Blondel Conformance

Consumers' Perspective

Figure C-1 Example

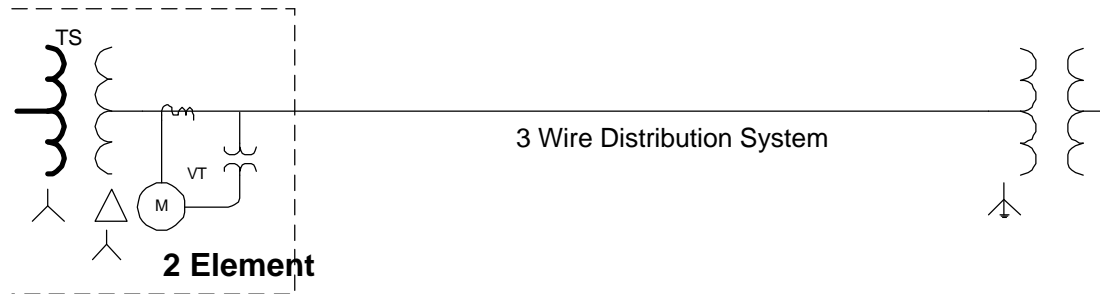
Transformer station (TS) has a wye secondary that is grounded through impedance or is solidly grounded. The ground/neutral is not brought outside the transformer station. Metering installation located inside the transformer station consists of three current transformers and three voltage transformers connected phase to ground/neutral and are inputs to a 3 element meter.

3 Wire Distribution System supplies delta or wye ungrounded loads.
Metering installations located within the distribution system are 2 element.

Load-end Considerations

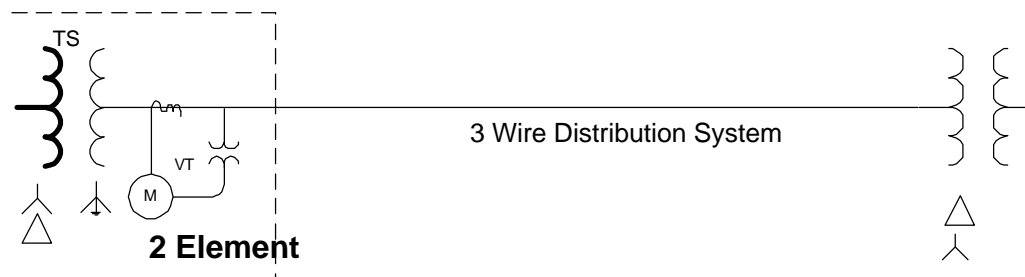
Blondel Conforming

Blondel NON- Conforming ??

What makes this non-conforming ?

What effect does skywire have on Blondel conformance in these cases ?

High Voltage Metering

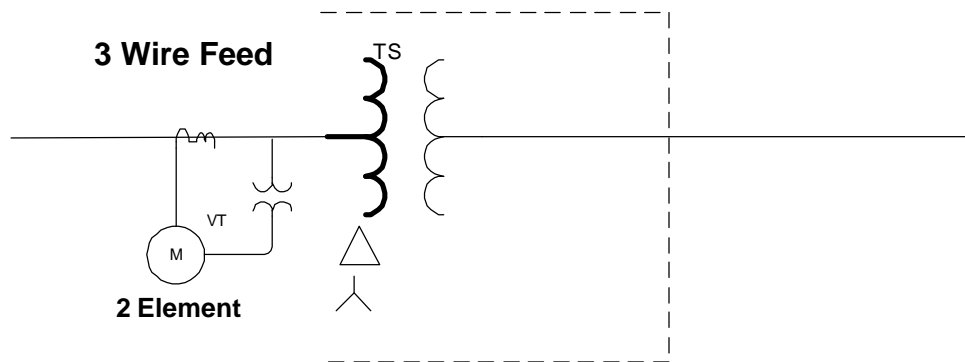
Blondel NON-Conforming ???

MSPs are specifying 3-element if major upgrade required

But what about ?

- 3 Wire Distribution System supplies delta or wye ungrounded loads. Metering installations located within the distribution system are 2 element.
- Does this mean this installation is “Blondel conforming” ?
